FIELD CHANGE ORDER

NUMBER: DS-650Q6-F001

PROBLEM & SYMPTOM: Cross-talk problem between Dispatcher cable and switched cable. Revision incompatibility problem between M7764-00 and M7763-00 module
(Continued on Page 3)

INTERCONNECTION OF MIRA MODULES (SYSTEM A only is shown)

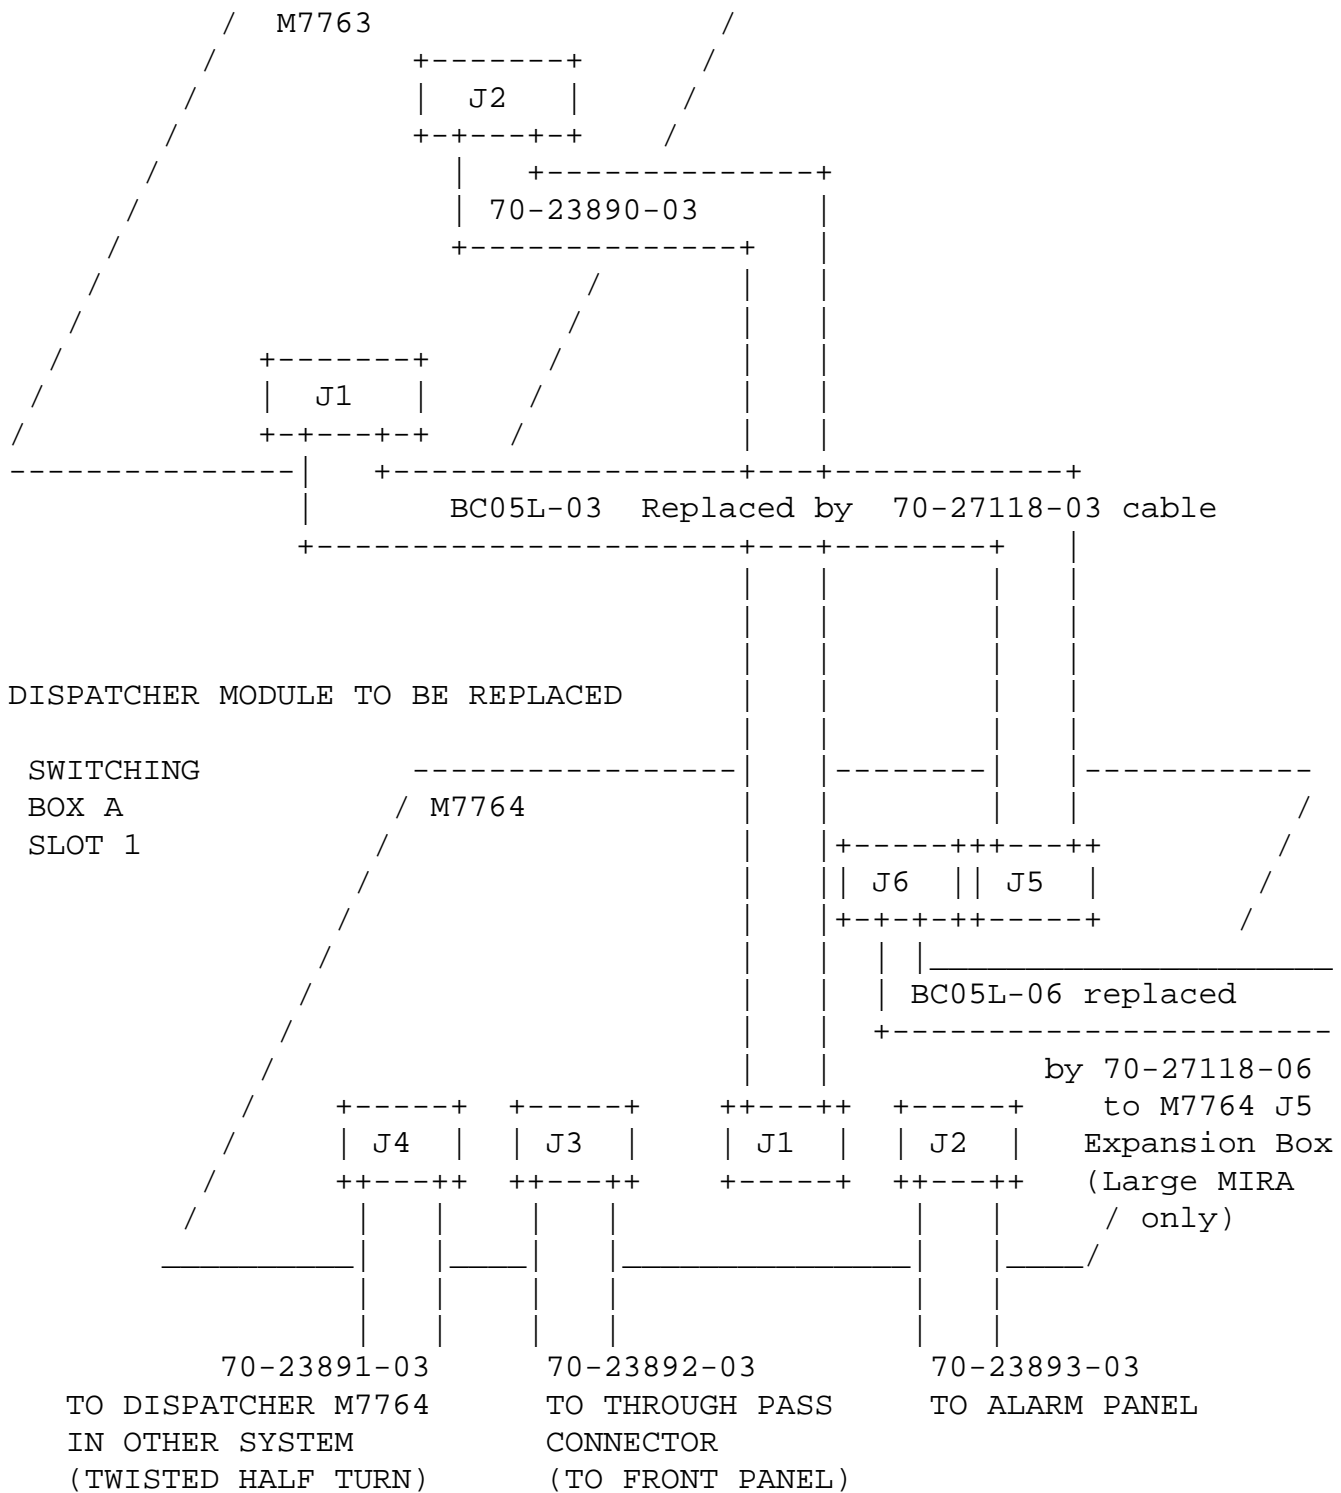
WATCH DOG MODULE TO BE REPLACED

COMPUTER A
CPU BOX SLOT 3

The interconnection of the modules and cables to be replaced is shown on Page 4.

Replace all modules M7763 and M7764 at Revision D or below by new modules at Rev. E and replace BC05L dispatcher cables at one time.
